Dear Gloria Pietropoli, Luca Manzoni, and Gianpiero Cossarini,

I would like to thank the authors for their efforts to improve the manuscript. It now reads much more smoothly and the consistent use of terminology to describe items/aspects make it much easier understandable.

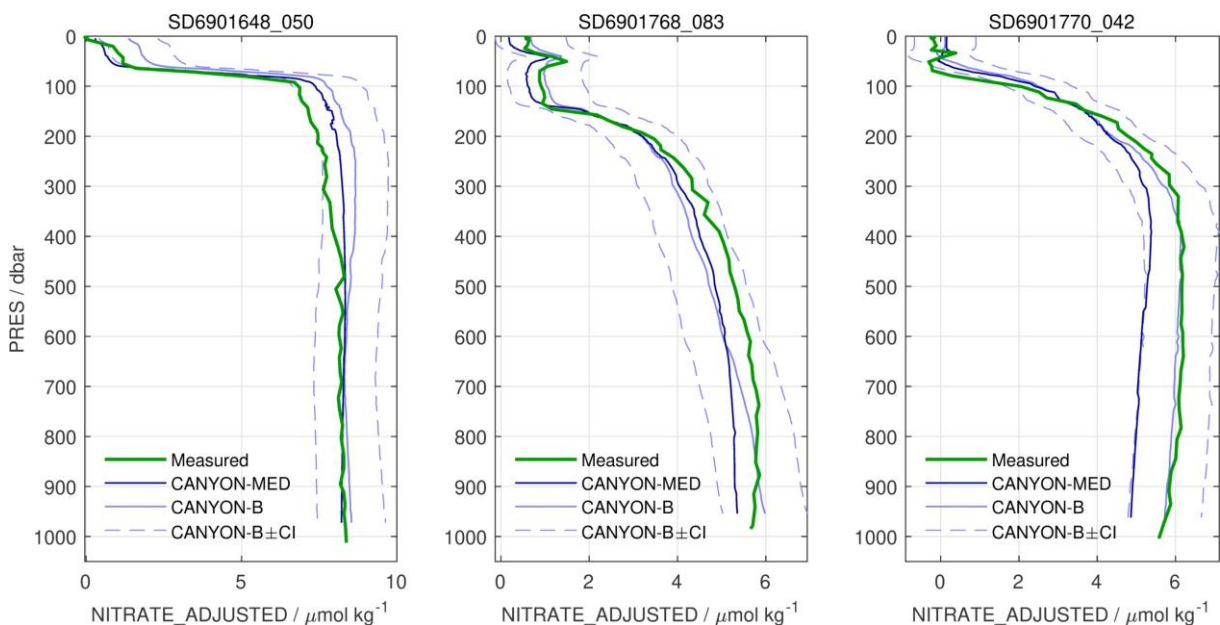
The parameter space in the Ocean is continuous and smooth (with a large thanks to mixing). Just for illustration: Below two T-S diagrams for two of the floats used. (Quality-controlled) Ocean data are smooth to start with.

Going along a profile step-by-step (both in parameter space or against depth) gives only small, step-wise modifications of the variable to be predicted and the variables used as predictors alike. Which means that, at any given point in parameter space, you have a certain idea of how your environment will look like: Probably not an awful lot different, but just a little. I.e., even if only given point-wise knowledge at a time, MLPs do have an awareness of how their profile will look like nearby (i.e., not a

lot different). I.e., there is (some) spatial awareness of profile shape in MLPs, too, due to point-wise proximity in parameter space and due to the Ocean's parameter space being smooth.

Same as Fig. 3 but with measured float data directly from the GDAC and two MLPs added (dark blue: CANYON-MED, light blue: CANYON-B).

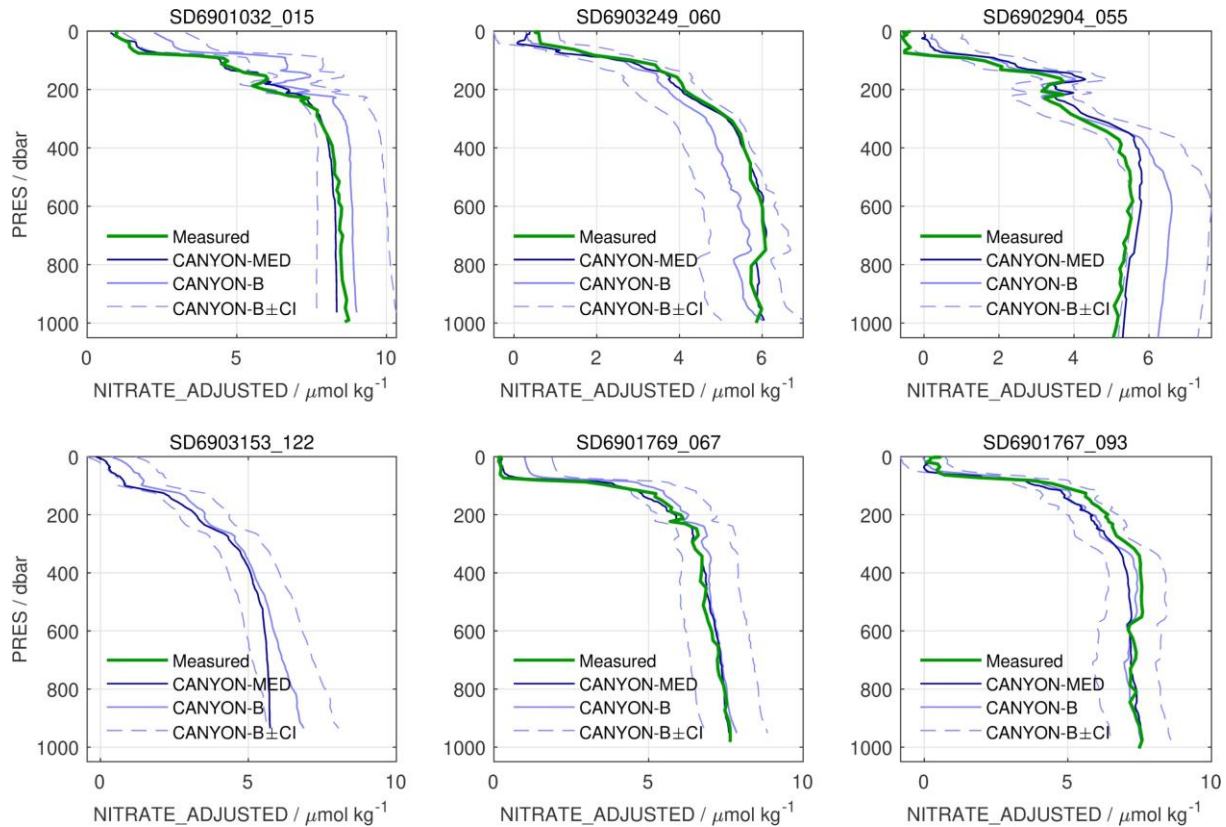
So I am left with claims where my arguments run against them. The two claims are brought up again in l. 68-73 but without illustration. So when coming to Figure 3 (nitrate profiles for selected floats), I wondered why the measurements and PPCon are shown but the Pietropolli et al. 2023a MLP comparison (as well as other MLPs for comparison like CANYON-MED, CANYON-B) were dropped?

Thank you for adding the WMO and profile numbers, which allowed me to go search for the data and do those comparison plots on my side. Here's what I get for the measurements as well as the two MLPs where I had access to the code for prediction: CANYON-MED (specifically trained on the Med Sea with a dataset extended beyond GLODAPv2) and CANYON-B (trained with very little Med Sea data from GLODAPv2, so no great performance to expect; but it provides confidence intervals, which I find instructive):

From the comparison, I find it rather comforting and confirming my line of argument that the MLPs give a similarly smooth profile shape as the CNN (in the manuscript Fig. 3) and no irregularities or jumps in the profile – unless governed by the water mass properties (e.g., middle profile just shallower than 50 dbar) and seen in the measured nitrate, too. (As said, I could not confirm/falsify whether the EMODNET-based Pietropolli et al. 2023a MLP shows irregularities or jumps in the profile.)

What I find a bit discomfoting is that the measured data in my case looks not the same as shown in Figure 3 of the manuscript: All profiles in Fig. 3 are much smoother (e.g., base of the mixed layer is significantly eroded; interleaved water mass around ~50 dbar in middle panel fully absent) and also the

bottom portion of the middle profile has a different shape (and value). I have confirmed the profile's locations and dates that I used – they match to the floats and cycle numbers (Thank you for Table 5)!
